# Access Compliance Report

## Public Rights-of-Way

Intersection ID: 45296	Main Street: ANN_MARIE_DR	Cross Street: PRESIDENTS_CT	Location: NW
ADA ID: E9AE08444D90	Ramp Type: PerpDiag	Initial Pass/Fail: Fail	Overall Compliance: No
		Severity Score: 10

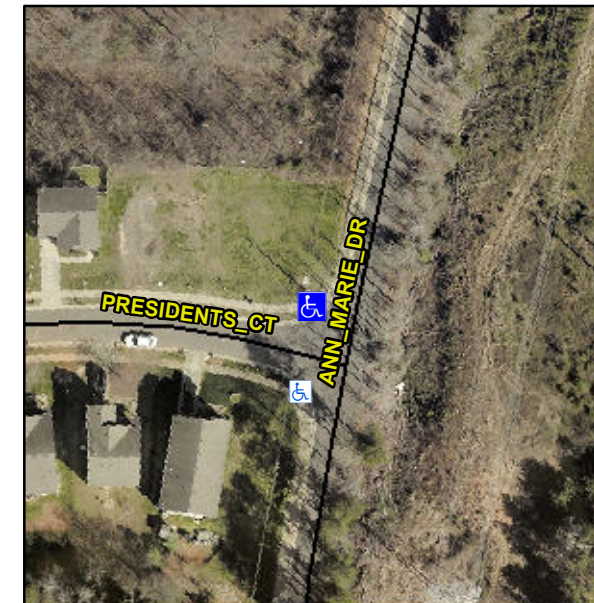
**R304.5.1, R304.5.3**

Compliance	Description	Data	Compliance	Description	Data
N/A	Ramp Length (in)	48.0	Yes	Ramp Slope (%)	7.9
No	Ramp Width (in)	45.0	No	Ramp XSlope (%)	3.4
N/A	Flare Type LT	N/A	N/A	Flare Type RT	N/A
N/A	Flare Slope LT (%)	N/A	N/A	Flare Slope RT (%)	N/A
N/A	Flare Traversable LT?	N/A	N/A	Flare Traversable RT?	N/A
N/A	Landing Length (in)	N/A	N/A	DWS Provided?	N/A
N/A	Landing Width (in)	N/A	N/A	DWS Contrast?	N/A
N/A	Landing Slope (%)	N/A	N/A	DWS Length (in)	N/A
N/A	Landing X Slope (%)	N/A	N/A	DWS Full Width?	N/A
N/A	Landing Curb? (Y/N)	N/A	N/A	DWS Offset (in)	N/A
N/A	Shared Landing?	N/A			
N/A	Gutter Ponding?	N/A	N/A	Gutter Slope (%)	N/A
N/A	Gutter Lip Ht (in)	N/A	N/A	Gutter X Slope (%)	N/A
N/A	Painted X Walk1?	No	N/A	Painted X Walk2?	No
	X Walk 1 Direction	To SW		X Walk 2 Direction	To SE
N/A	X Walk 1 Width (in)	N/A	N/A	X Walk 2 Width (in)	N/A
	X Walk 1 Slope (%)	10.9		X Walk 2 Slope (%)	3.7
	X Walk 1 X Slope (%)	5.3		X Walk 2 X Slope (%)	10.6

**Remove & Replace Curb Ramp With Two New Directional Ramps or Equivalent.**
